Date of Issue: April 2014

Affected Publication: API Recommended Practice 19B, *Evaluation of Well Perforators*, Second Edition, September 2006, Reaffirmed April 2011

ADDENDUM 1

Figure 9—Typical Axial-Flow Permeability Equipment

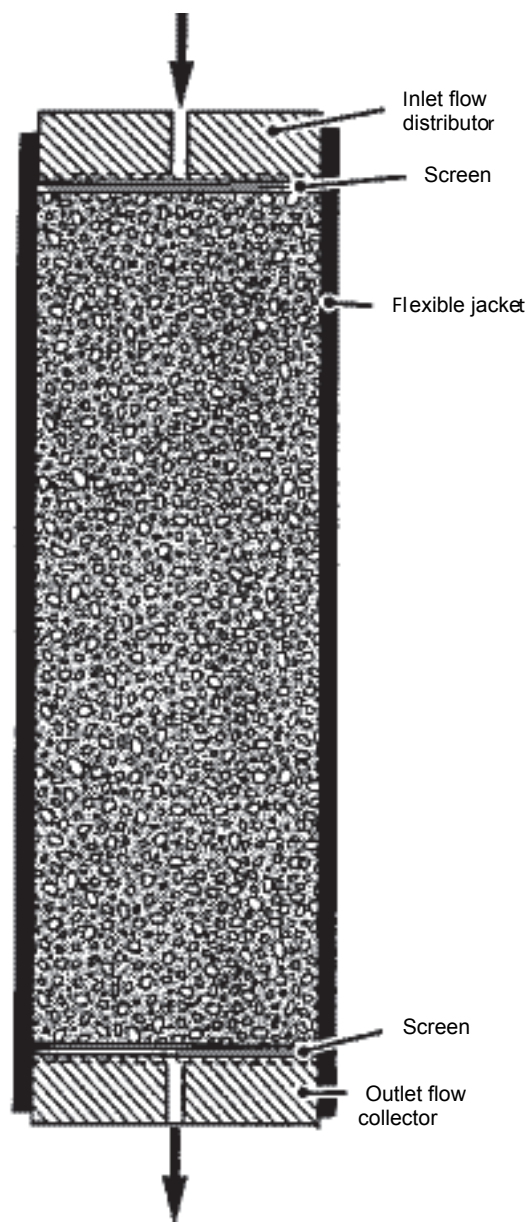
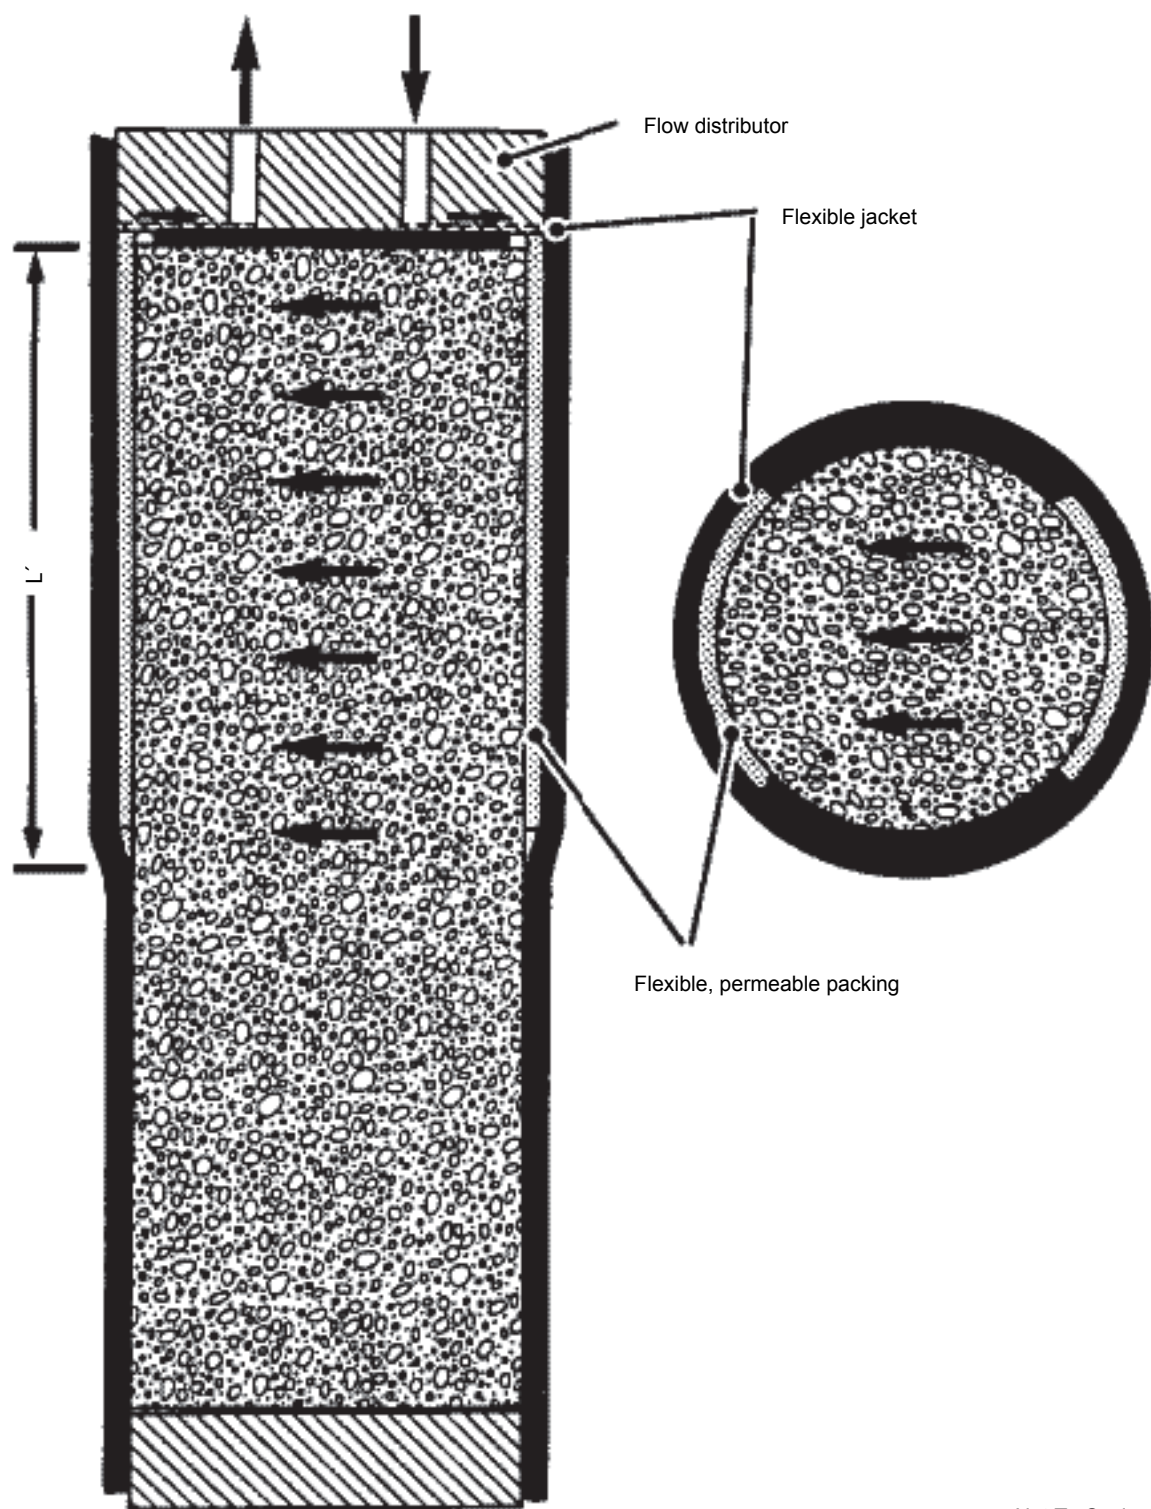
Figure 9 demonstrates a typical axial flow boundary condition setup applicable for permeability measurement. The target is configured with a constant pressure boundary condition on each end of the core and a no flow boundary condition on the core OD. This is best accomplished with a flexible jacket on the core OD and a flow distributor on each end of the core. Concentric ring distributors are recommended. Distributor design should be such that local stress and flow restriction effects are minimized. Screen may be used in conjunction with the flow distributors in order to minimize local effects of the distributors.

Convergent flow measurements are acquired in a setup similar to that shown in Figure 9, with the exception that a restriction plate is added to the outlet end of the core. The restriction plate should incorporate a sealing gasket in order to restrict the flow to a central opening. The diameter of the restriction hole should be such that the ratio of the open area to the area of the core face is approximately 1:50. For example, the appropriate diameter for a 5 inch diameter core shall be 0.75 inch, and the appropriate diameter for a 7 inch diameter core shall be 1.00 inch.

Figure 10 illustrates a typical diametral permeability measurement setup. The core is configured with a constant pressure boundary condition on two opposite 90 degree arcs of length L' , and a no flow boundary condition on all other surfaces of the core. The ratio of L' to the total length of the core affects the calculation of cross diameter permeability as shown in Section 4.10.1. In general the length of L' should be at least the length of the expected perforation tunnel. The annular gaps between the sample jacket and core OD shall be filled with a stress transmission media with permeability at least 100 times greater than the expected permeability of the test core. In most cases, steel rods or a high strength proppant can provide this capability. The ends of the core must be sealed to ensure that all flow passes across the diameter of the core. There are several ways to accomplish this, and it is left to the discretion of the testing company to select a method and then do the required testing to assure that there is no leakage.

Figure 11—Schematic of Typical Testing Equipment

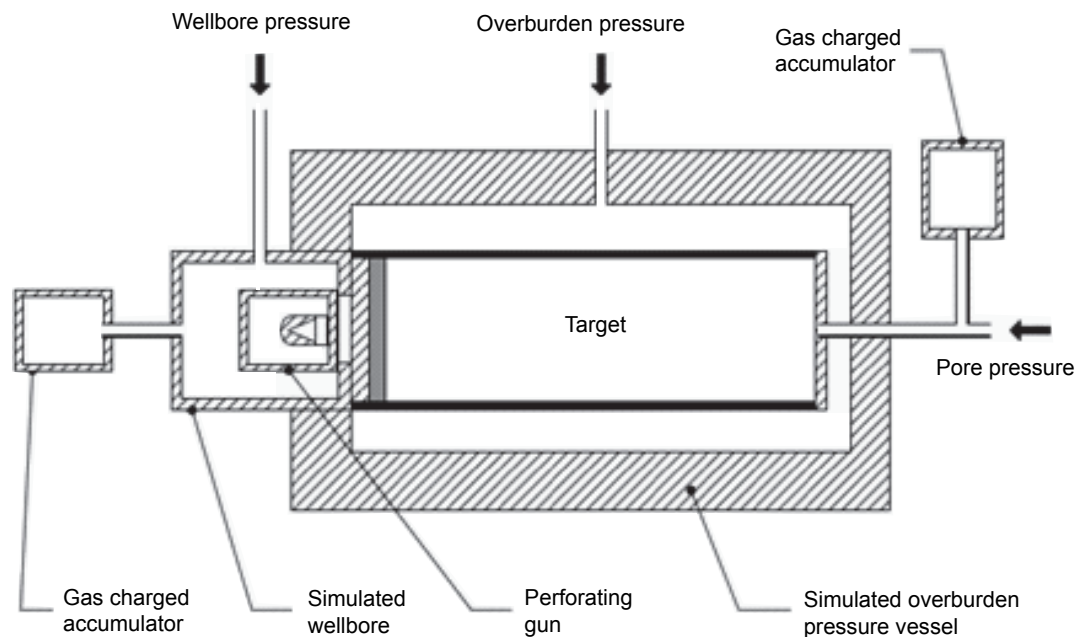
Figure 11 illustrates a typical testing equipment schematic. The testing equipment required for a Section 4 experiment shall generally consist of the following:

Figure 12—Typical Radial-Flow Geometry

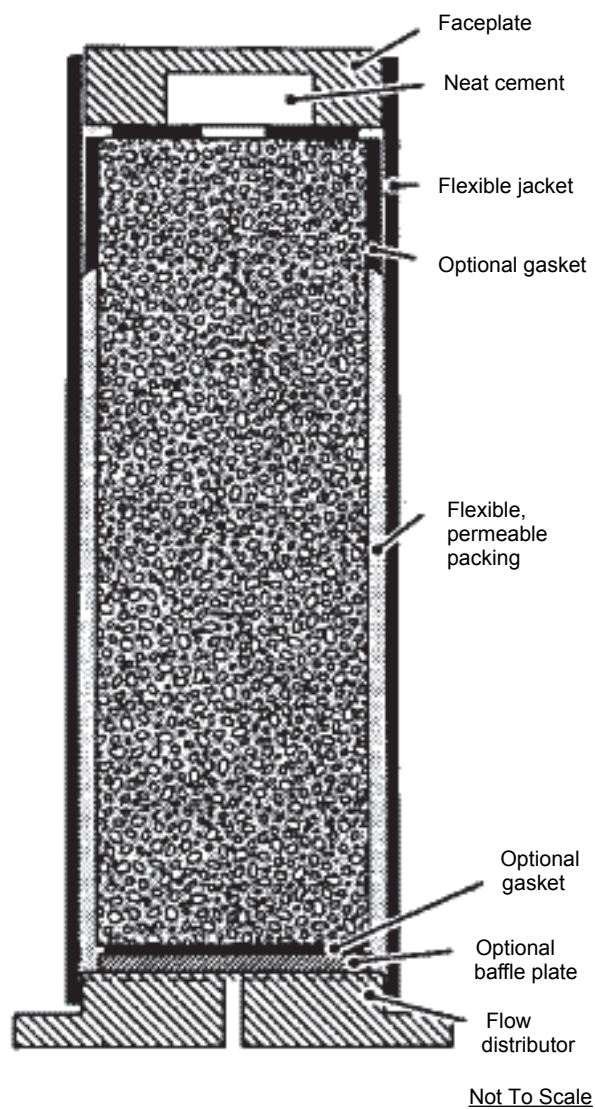
4.6.2 For radial flow geometries, the target is configured with a constant pressure boundary condition on the core OD surfaces, an optional constant pressure boundary condition on unperforated end of the core, and a no flow boundary condition on the perforated end of the core. The annular gap between the sample jacket and core OD shall be filled with a stress transmission media with permeability at least 100 times greater than the expected permeability of the test core. Refer to Figure 12 for further details and descriptions. In most cases, a high strength proppant can provide this capability. This will address potential test artifacts concerning flow restrictions, media crushing, and poor stress transmission. The face of the perforated end of the core must be sealed with a gasket to ensure that all flow exiting the core comes by way of the perforation. There are several ways to accomplish this, and it is left to the discretion of the testing company to select a method and then do the required testing to assure that there is no leakage. The endcap on the unperforated end of the core should normally be configured to include a flow distributor to distribute flow across the entire face of the core and/or to direct fluid to the porous media surrounding the OD of the core.

Figure 13—Typical Axial-Flow Geometry

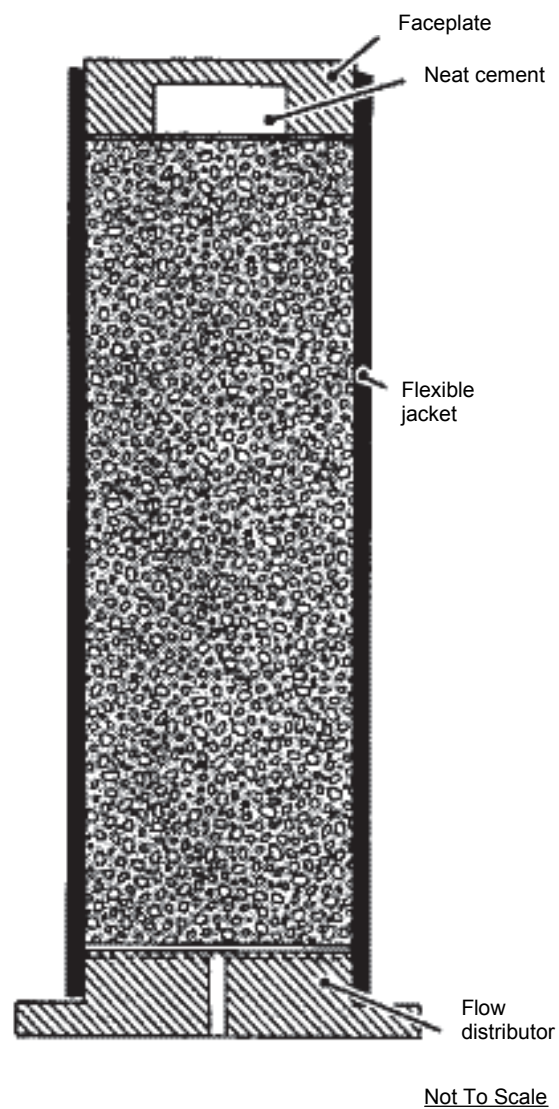
4.6.3 For axial flow geometries, the target is configured with a constant pressure boundary condition on the unperforated end of the core and a no flow boundary condition on the core OD and perforated end of the core. This is best accomplished with a flexible jacket on the core OD, a flow distributor on the unperforated end, and a sealing gasket on the perforated end. Refer to Figure 13 for additional description and details.

Figure 14—Productivity Index Data Reduction Graph

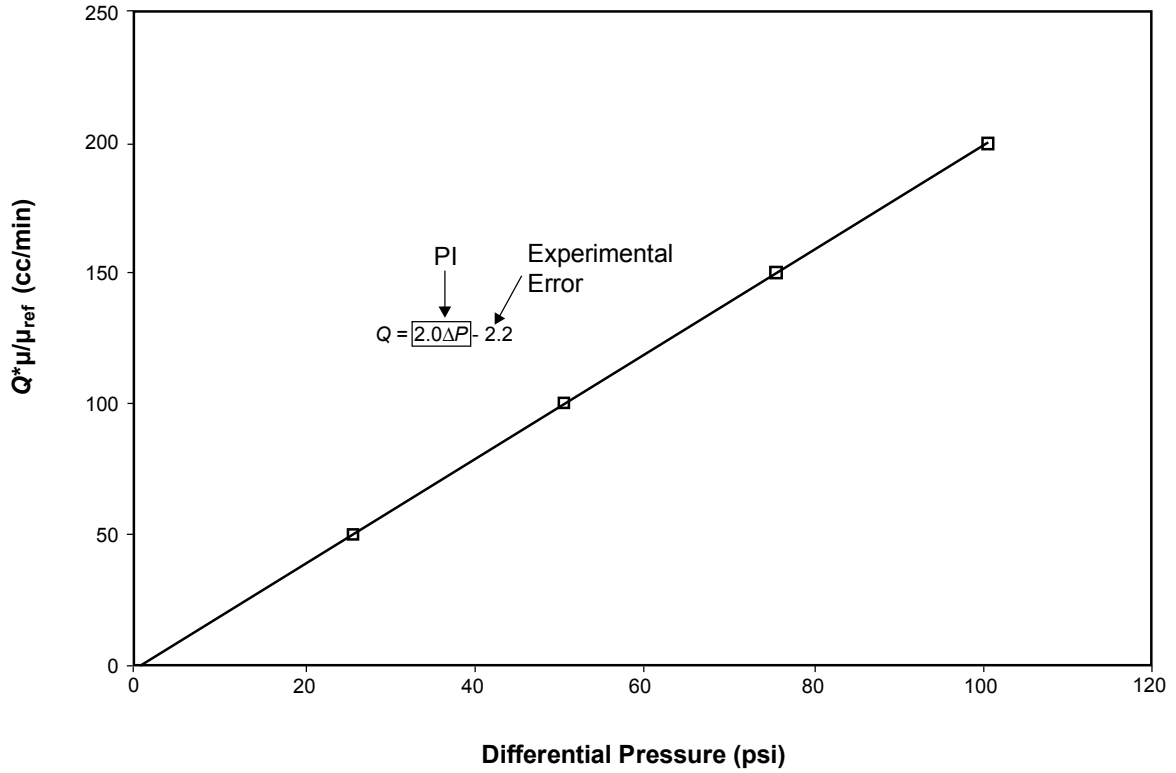
Productivity index (PI) is defined as the ratio of flow rate, corrected by viscosity of the fluid, to pressure drop and is determined from the slope of a linear curve fit through a corrected flow versus pressure drop data plot, as shown below in Figure 14. PI is only valid within the context of a given set of test conditions and is dependent upon such things as boundary conditions, target properties, and fluid properties.

Figure 15—Example Gas Flow Curve Fit to Determine a_1 and a_2

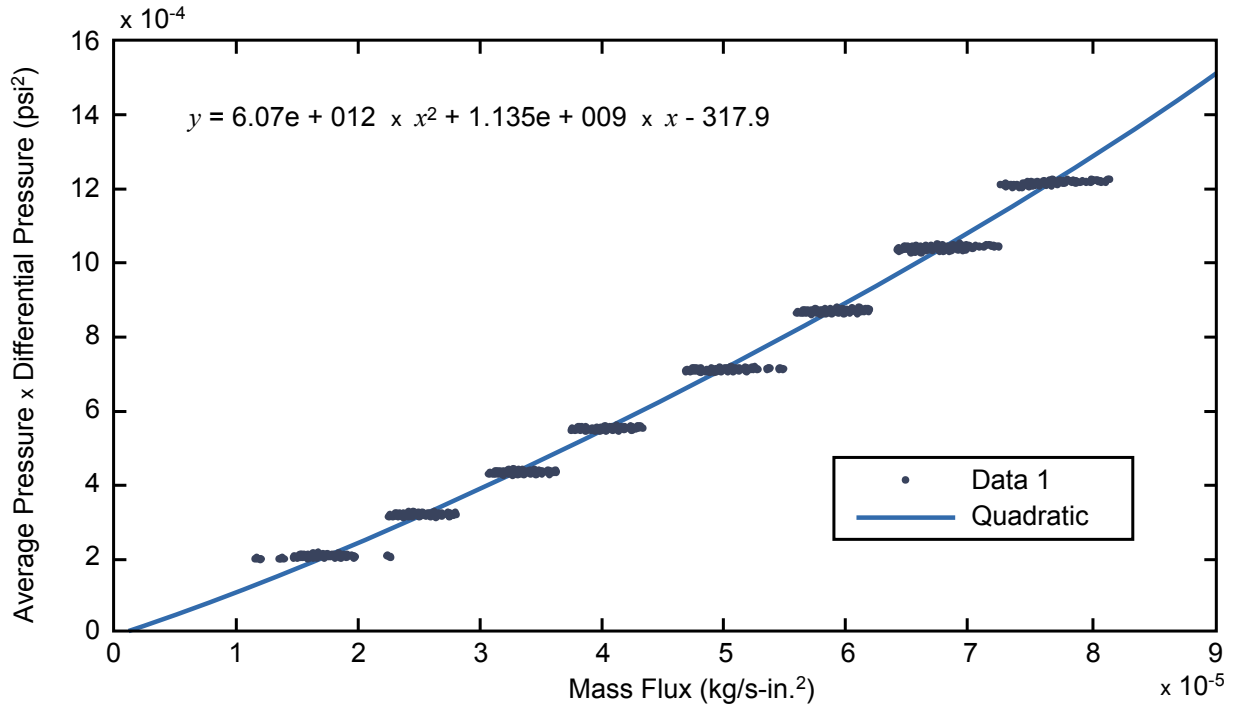
The linear and quadratic coefficients, a_1 and a_2 respectively, are obtained by graphing the pressure and mass flux data as demonstrated in Figure 15 and calculating a quadratic equation curve fit in the form of $y=a_2x^2+a_1x+c$.

Figure 16—Post-Shot Radial Flow for a Gas Saturated Core

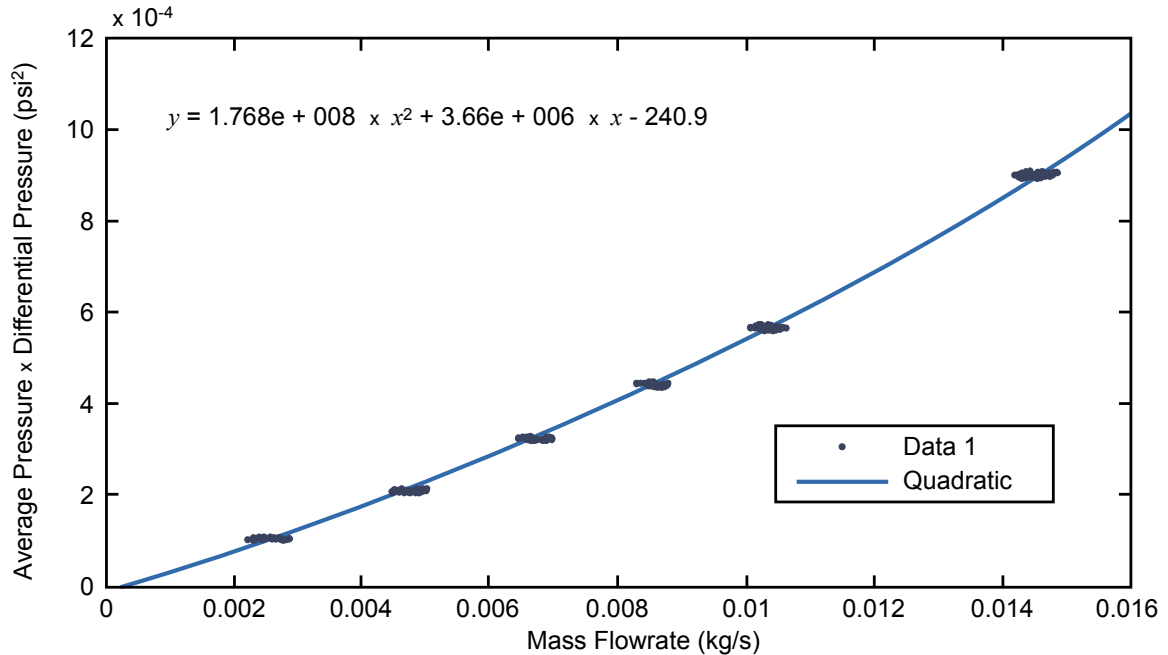
Note: Evaluation of a_1 and a_2 for radial flow requires fitting a quadratic curve to a plot of the average pressure times the pressure difference vs. the mass flow rate in kg/s, not the mass flux (kg/in.²-s), as shown in Figure 16.
